TECHNICAL SERVICE BULLETIN

-LG1+ pedals

Abstract: LG1+ pedals have been updated for 2013 with a few new features. Please see below for details. New pedals can be identified by their date code. Pedals with date codes greater than 15F have the new features.

How to identify:

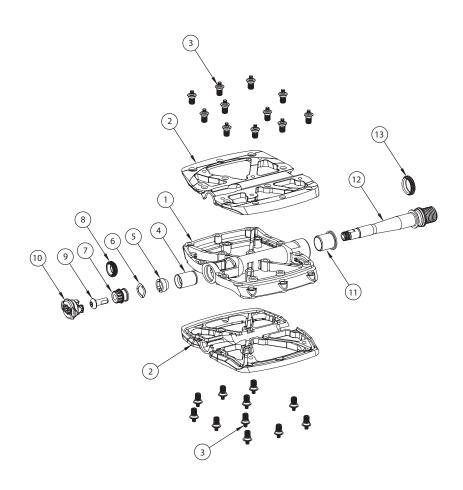
Pedals with date codes of 15F or greater (ex. 16F, 15G) are gen2 pedals, date codes less than 15F (14F, 15E) are gen1 pedals. Thread size used for the pins can also show if a pedal is gen1 or gen2. Gen1 pedals use an M5 pin thread, gen2 pedals use a M4 pin thread.
